Access Compliance Report

Public Rights-of-Way

(Pedestrian Signals)

Intersection ID: N/A	Main Street:	Cross Street: N/A	Location: N/A
ADA ID: 48B1E794F920	Signal Type: One Push Button-Non APS	Overall Compliance: No	Severity Score: BTN 1: N/A BTN 2: N/A No BTN: N/A
Codes/Mitigation Info/Possible Solution		Field Measurements/Component Compliance

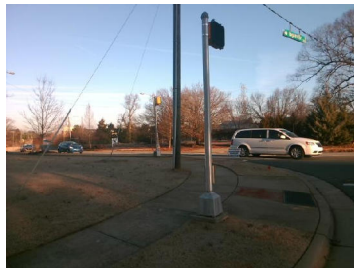
PROW/ADA: R404.2, R404.3

Possible Solutions: Remove and Replace Clear Space.
